Groundwater Application Review Summary Form

Application # G- 13769
GW Reviewer DENNIS ORLOWSKI Date Review Completed: 2/7/2019
Summary of GW Availability and Injury Review:
[] Groundwater for the proposed use is either over appropriated, will not likely be available in the
amounts requested without injury to prior water rights, OR will not likely be available within the capacity of the groundwater resource per Section B of the attached review form.
capacity of the groundwater resource per section but the attached review form.
Summary of Potential for Substantial Interference Review:
[] There is the potential for substantial interference per Section C of the attached review form.
Summary of Well Construction Assessment:
[] The well does not appear to meet current well construction standards per Section D of the attached
review form. Route through Well Construction and Compliance Section.
This is only a summary. Documentation is attached and should be read thoroughly to understand the

Application G-18769 Townsend Farms Inc.

Water-Level Trends in Nearby Wells

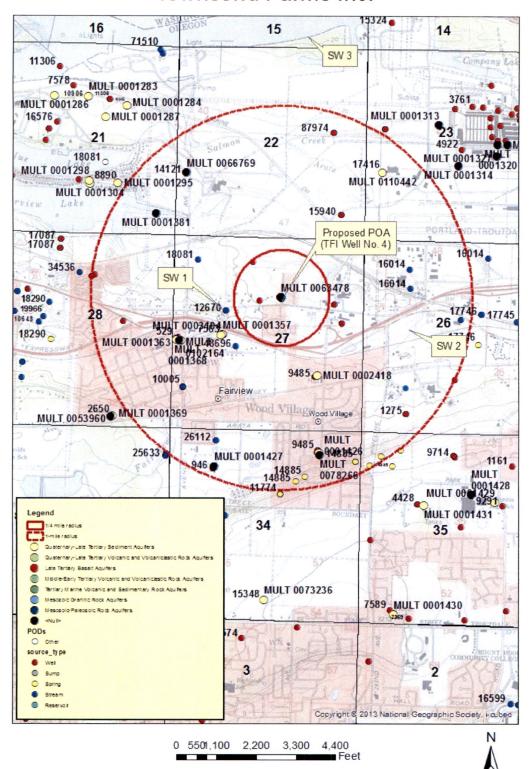
d.	Well reconstruction is necessary to accomplish one or more of the above conditions. The problems that are likely to occur with this use and without reconstructing are cited below. Without reconstruction, I recommend withholding issuance of the permit until evidence of well reconstruction is filed with the Department and approved by the Groundwater Section.											
		Describe injury –as related to water availability– that is likely to occur without well reconstruction (interference w/ senior water rights, not within the capacity of the resource, etc):											
В3.	Swa con grou	bundwater availability remarks: The Sand and Gravel Aquifer (SGA) is exploited primarily by municipal water viders, with some additional pumping for commercial and industrial uses in the area (McFarland and Morgan, 1996; anson and others, 1993). The SGA is a prolific groundwater source due to its generally-high transmissivity and nection with the Columbia River and other local surface water bodies. However, although current large-scale undwater use in the immediate area is moderate, future demands on the SGA are anticipated to increase as municipalities

and their local groundwater sources. Furthermore, long-term groundwater level data from SGA wells is very sparse, with ilable data extending only to the early 1990s (see attached hydrograph). Consequently, the recommended permit

conditions are proposed to help protect the groundwater resource and existing users.
